AGENDA
PLANNING & ZONING COMMISSION
City Commissioner's Room
118 S. Cage Blvd. July 11, 2022 – 6:00 PM

BOARD: Planning & Zoning Commission

LA PIEDAD SUBDIVISION

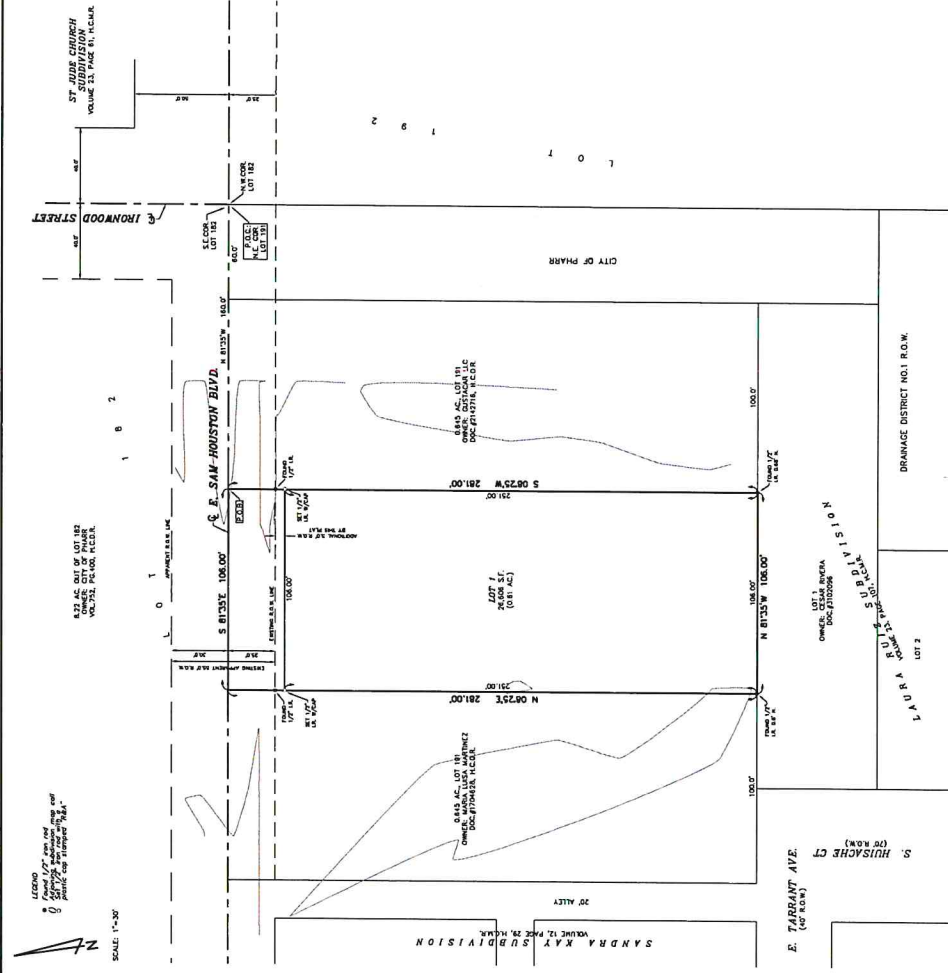
1. Need signatures on plat (engineer and surveyor).
2. On metes & bounds verify the second paragraph callout on subdivision name.
3. Need to apply for a change of zone property is currently agricultural.
4. Update year on signature blocks.
